City of Franklin

Meeting Agenda

Franklin Municipal Planning Commission

Thursday, June 25, 2015

7. Landscape Plans

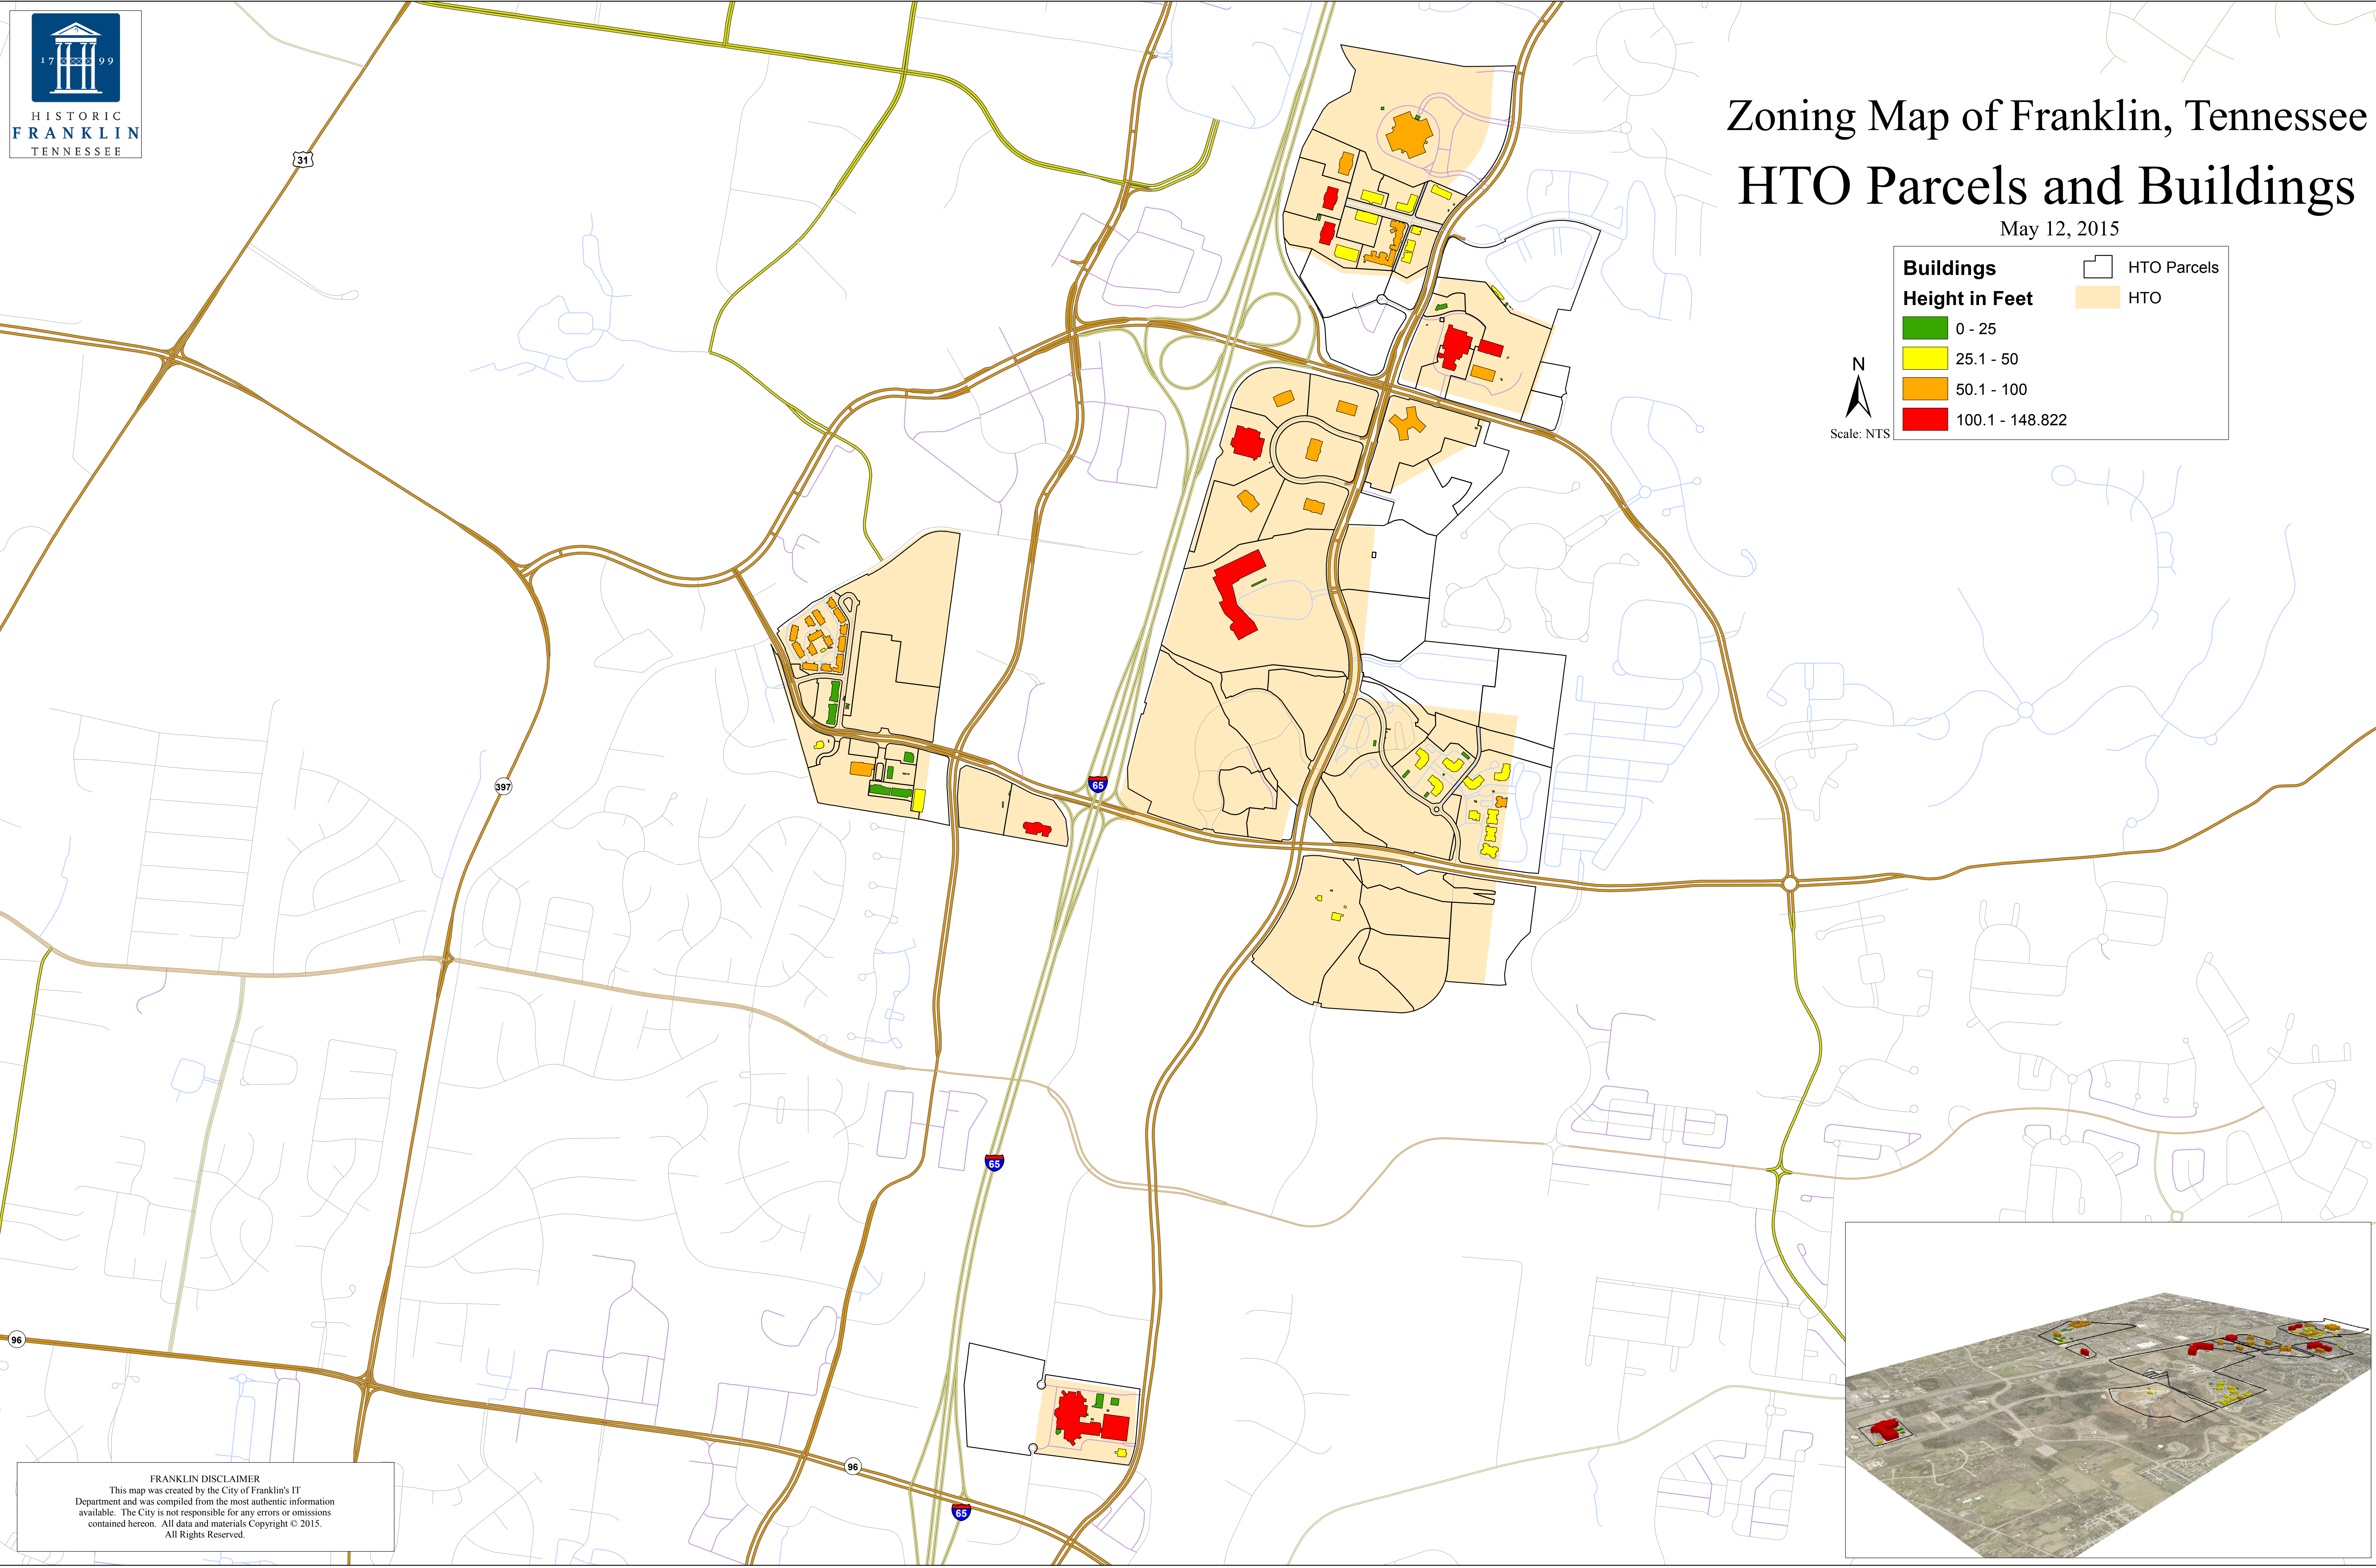
- Applicant shall clearly show the limits of the HHO District on Sheet 1B-the overall site map.

- Applicant shall show all landscape sheets. Comment shall remain open until formal petition letter has been received.

- Tree protection fencing immediately adjacent to the limits of disturbance (as currently shown) is required. All other tree protection fencing extending well beyond the limits of disturbance is not required (see sheet 4).
